REQUEST FOR INFORMATION	DATE: May 27, 2016	NO.: RFI-123
--------------------------------	---------------------------	---------------------

Project Name: 15051-Webster University Interdisciplinary Science Building	Project No.: 15051
---	--------------------

Subject: Dimensions for opening in level 2 floor

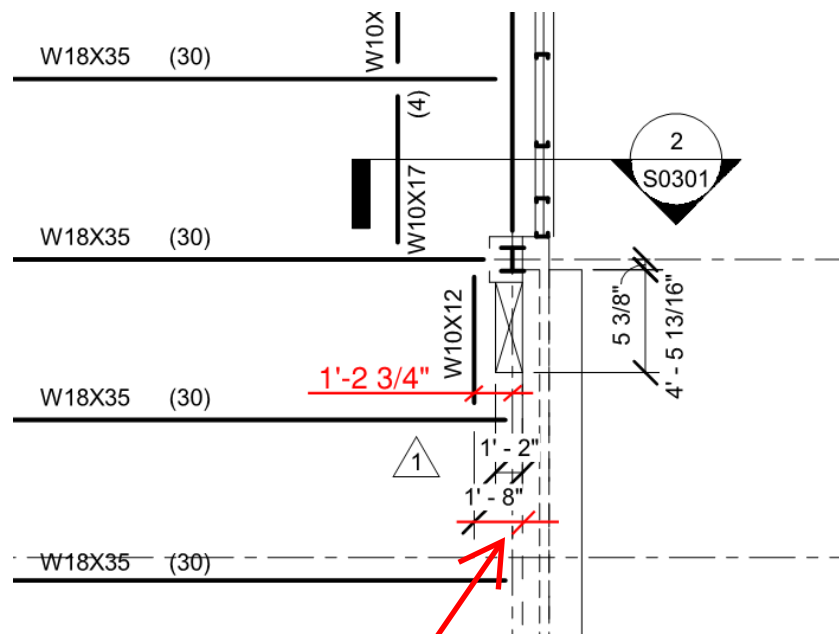
RFI 45 note 4 provided a dimension of 1'8" from the face of wall for the opening south of D along 8 line. Addendum 1-11 now shows this dimension at 1'2". Please clarify which dimension is to be used.

TICK MARK IS
LOCATED ON THE
WRONG LINE IN
ADD 1-11
